Airport Moving Map Alert

Subject: Ras Al Khaimah, UAE
Ras Al Khaimah Intl (OMRK)
Cycle 2412

TWY and Parking Stands layout incorrect.

OMRK_2412

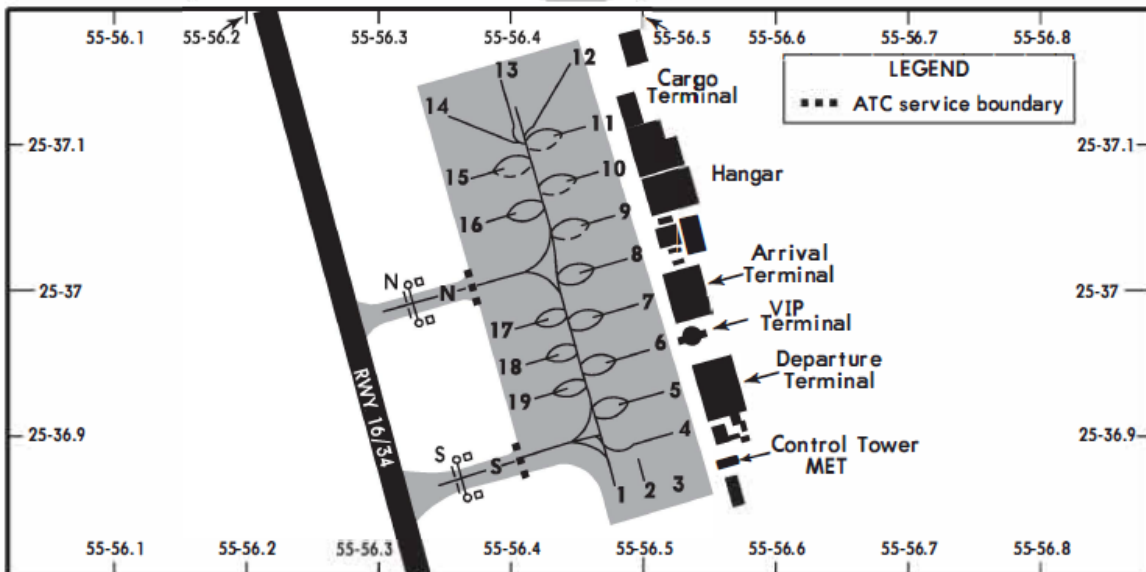
Jeppesen Airport Moving Map and A816 formatted data for cycle 2412, effective 28 November 2024, contain incorrect data for Ras Al Khaimah Intl; Ras Al Khaimah, UAE (OMRK). UAE AIP AIRAC AMDT 12/2024, effective 28 November 2024, has been postponed by NOTAM A3863/24, effective 28 November 2024 at 12:15 [UTC], after 2412 AIRAC cycle data processing due date. Therefore, the following changes, effective 28 November 2024, are not reflected in cycle 2412 data:

- TWY N1 and TWY S1 names are removed
- Parking Stands 17-19 (between TWY N and S) are added
- TWY (between TWY N and S) is added
- Parking Stands 1-16 layout is updated
- Taxiline (north of TWY N) layout is updated

Revised data will appear in Jeppesen Airport Moving Map and A816 formatted data for cycle 2413, effective 26 December 2024. Until then this Alert will be posted on the Jeppesen Web site: [Notices and Alerts](#). Please refer to the local NOTAMs and Ras Al Khaimah Intl, Ras Al Khaimah, UAE (OMRK) 10-9B chart dated 30 AUG 24, effective 5 SEP 24 for valid information.
